SNOHOMISH RIVER BASIN
INSTREAM RESOURCES PROTECTION PROGRAM
INCLUDING
PROPOSED ADMINISTRATIVE RULES, AND
SUPPLEMENTAL ENVIRONMENTAL IMPACT STATEMENT
(WATER RESOURCE INVENTORY AREA 7)

STATE OF WASHINGTON
DEPARTMENT OF ECOLOGY

August 1979

Figure 4.

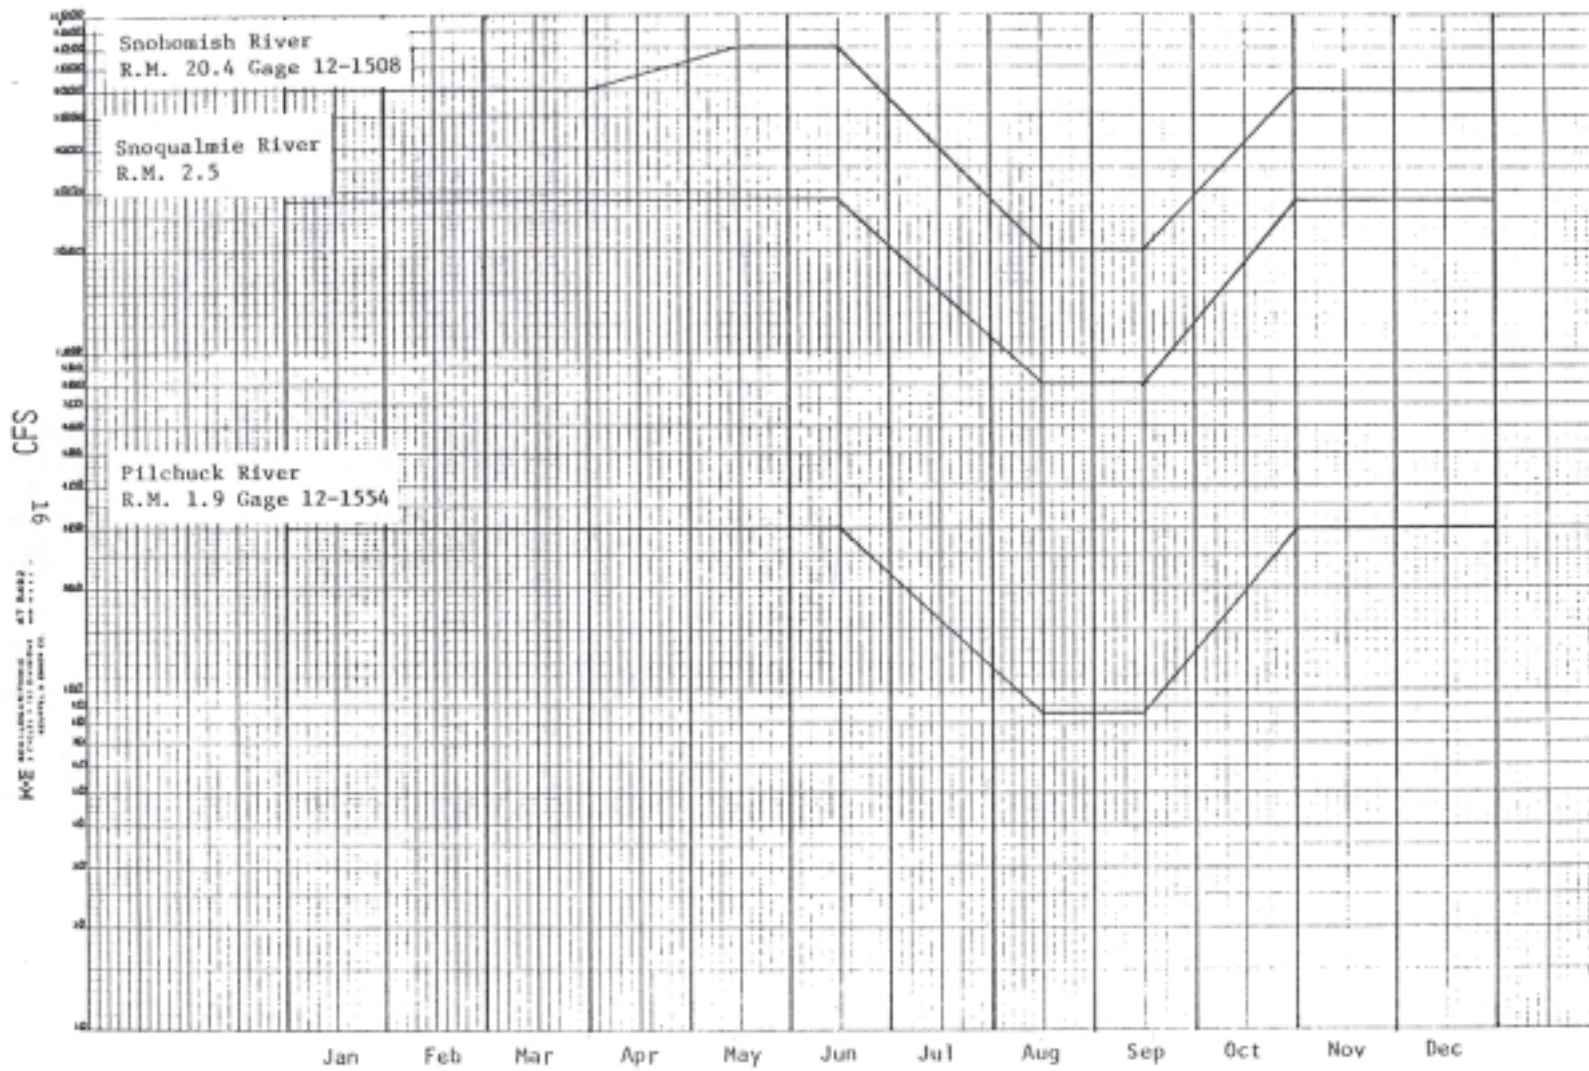
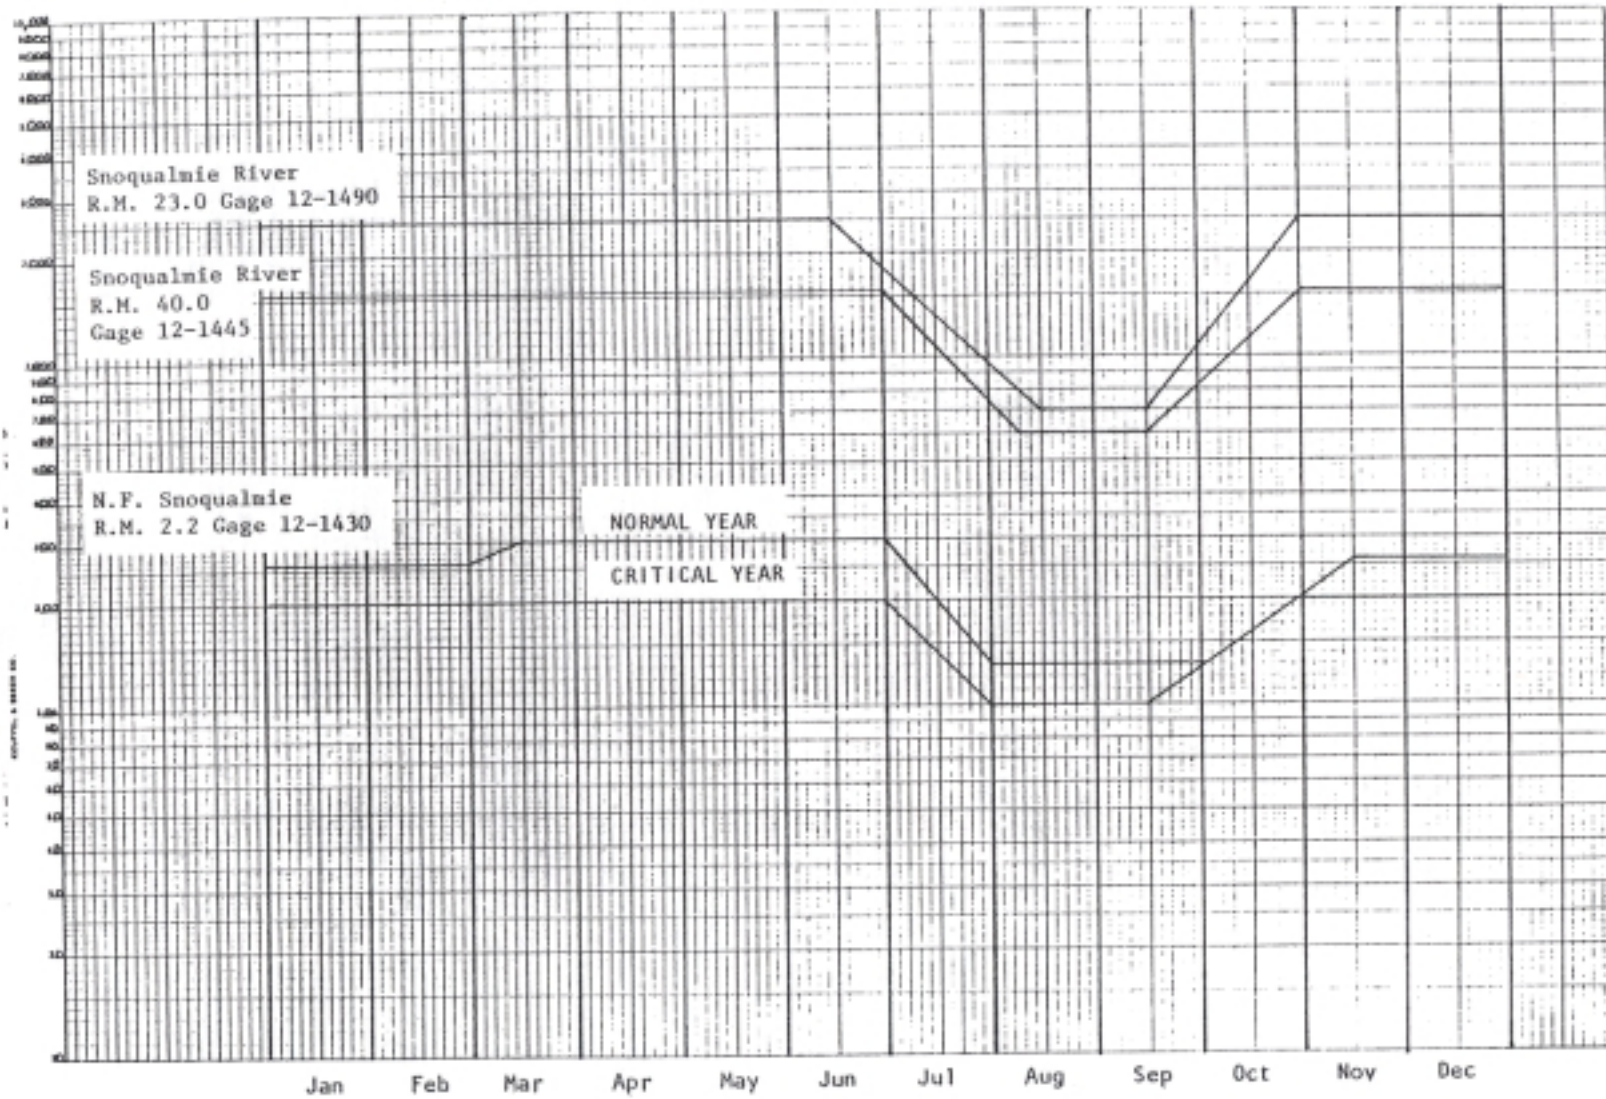
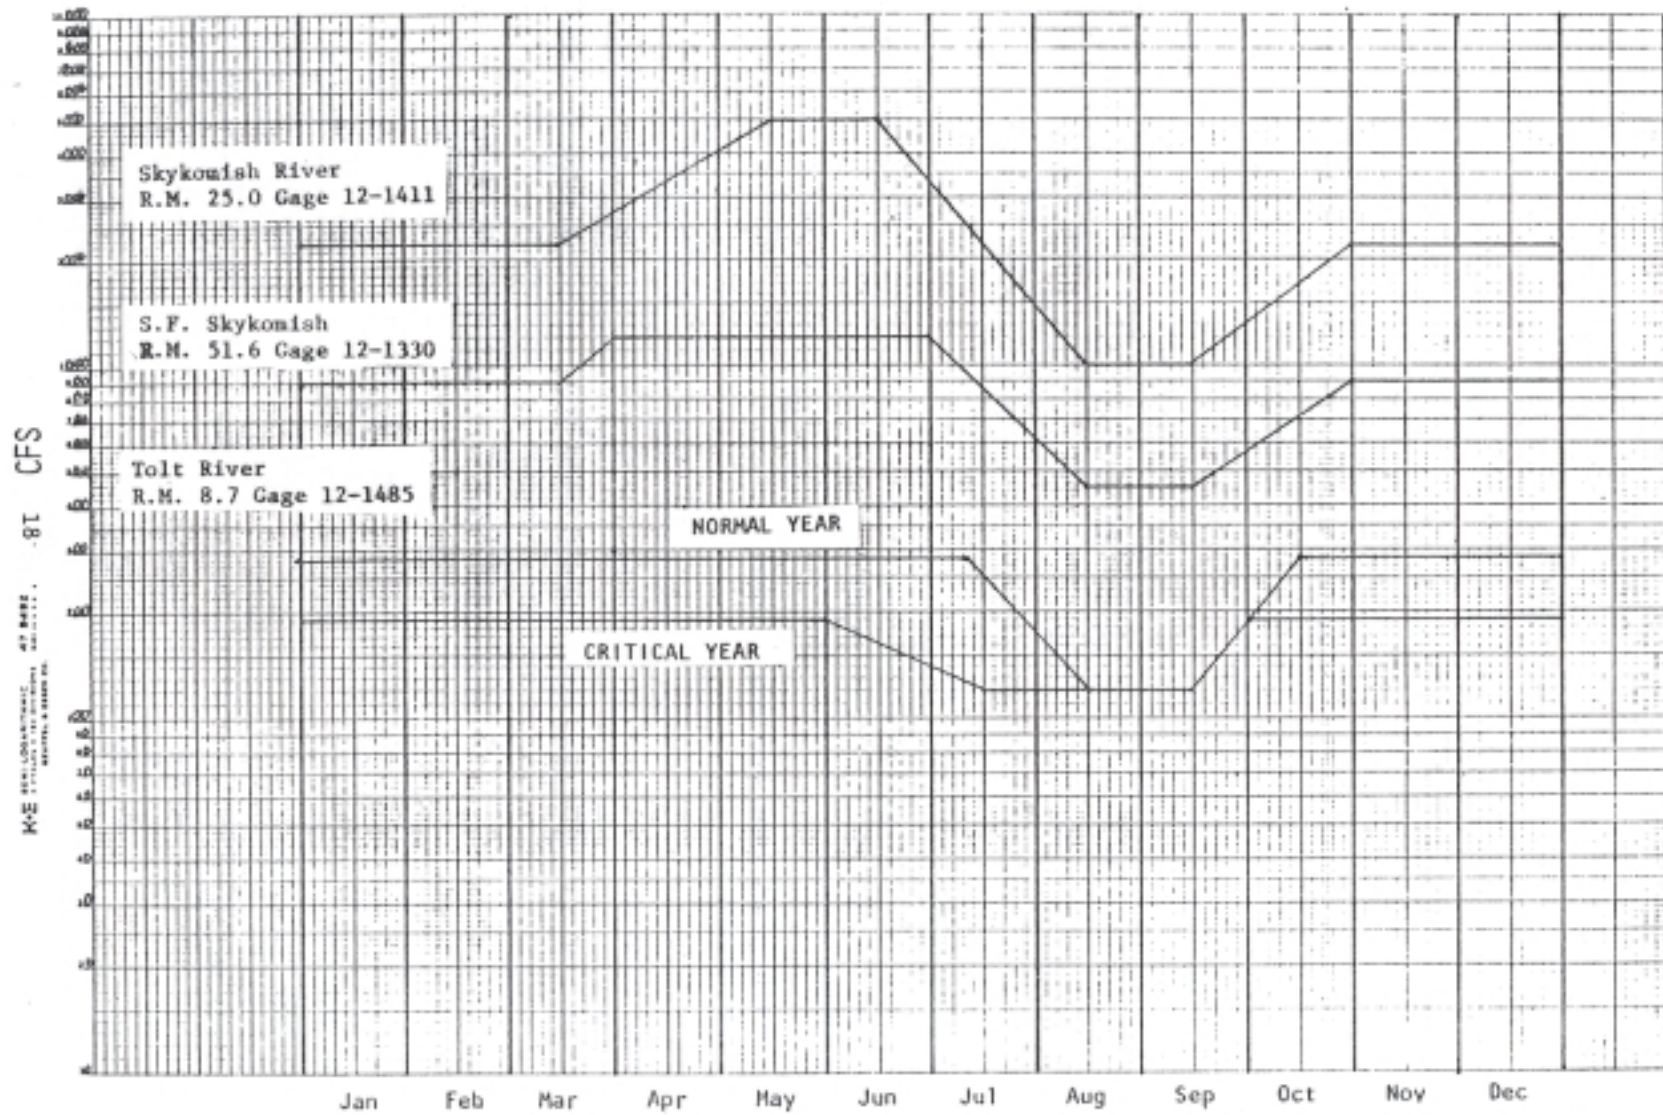
- 88** 4. Figure 4 - pages 16, 17, & 18. Controlling instream flow hydrographs are included for all control locations with the exception of No. 12.1381.50 (Sultan River). If one is to be established for the Sultan River, we would need sufficient time to review it with respect to Everett water rights and long term needs. The proposed hydro-electric plans of the Snohomish PUD could also have a maim impact upon instream requirements - depending upon the location of the control station.
